From: [REDACTED]
Sent: 13/10/2023 3:00:51 PM
To: Council Northernbeaches Mailbox
Subject: TRIMMED FW DA2023/1329 OBJECTION
Attachments: Objection to Northern Beaches Council- 11 Oct 2023.pdf; Revised Submission to Northern Beaches Council- 13 Oct 2023.pdf;

Re: DA2023/1329

Lot DP 29517 & Lot DP 413722 52 Hilltop Road, Clareville

Alterations and Additions to a Dwelling House including Construction of a Studio and Two Car Ports

Photo 3

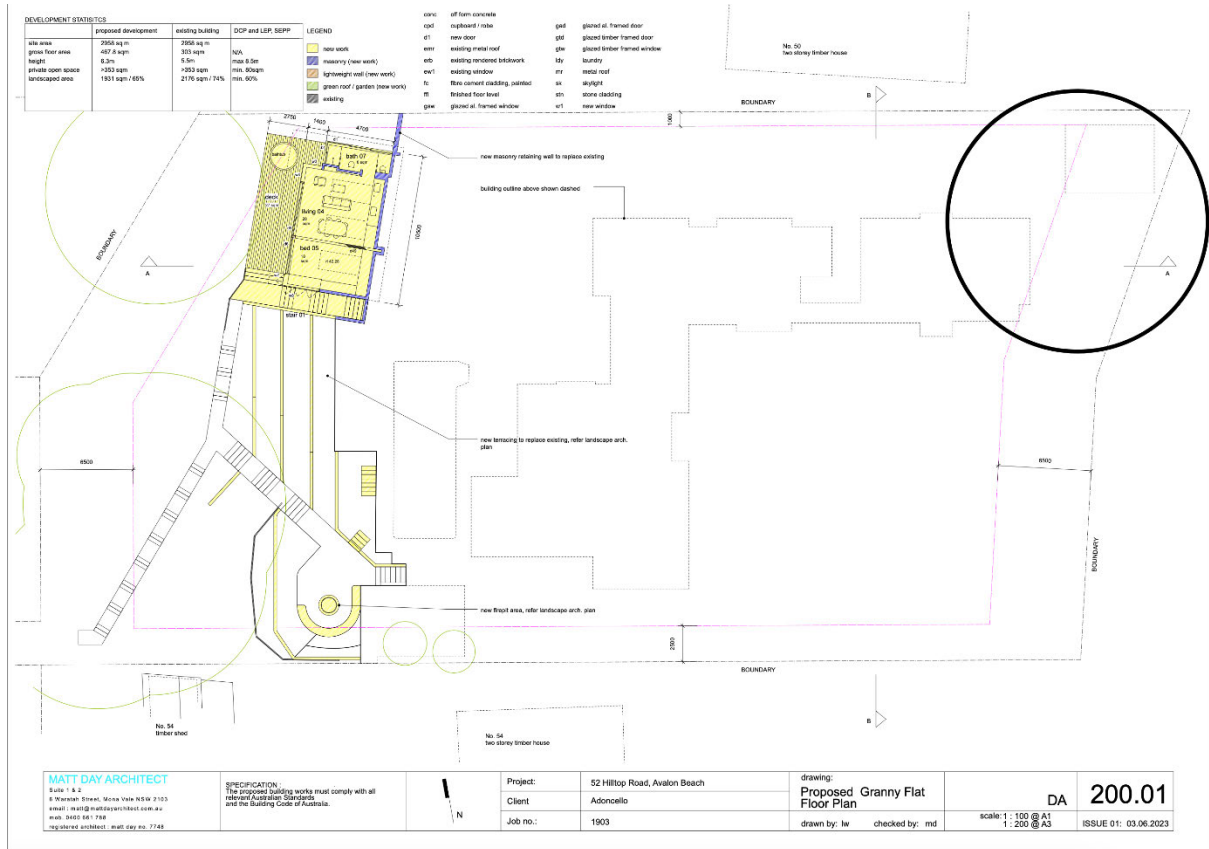
As stated, the proposal is a complete overshadow and invasion of our privacy and way outside the 2500 setback. See Photo No 3.

As stated, the proposal is a complete overshadow (not indicated on the plans) and invasion of our privacy and way outside the 2500 setback. See Photo No 3.

Photo 4

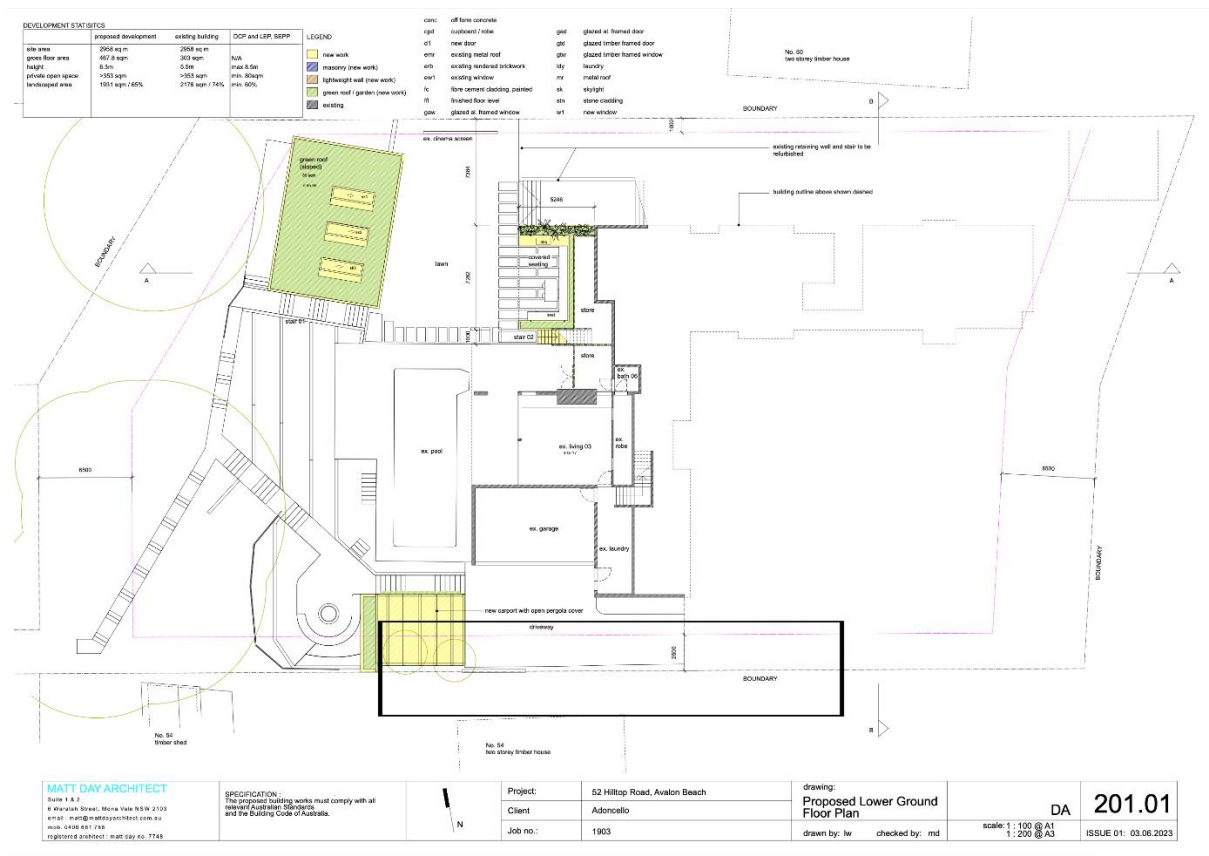
The fire pit DA200.01 and Photo No. 4 shows this structure being of an open fire in a bush area adjacent to our brush fence and our Pool House. Photo No 5. (not as stated on the plan as a timber shed!)

The fire pit DA200.01 and Photo No. 4 shows this structure being of an open fire in a bush area adjacent to our brush fence and our Pool House. Photo No 5. (not as stated on the plan as a timber shed!)
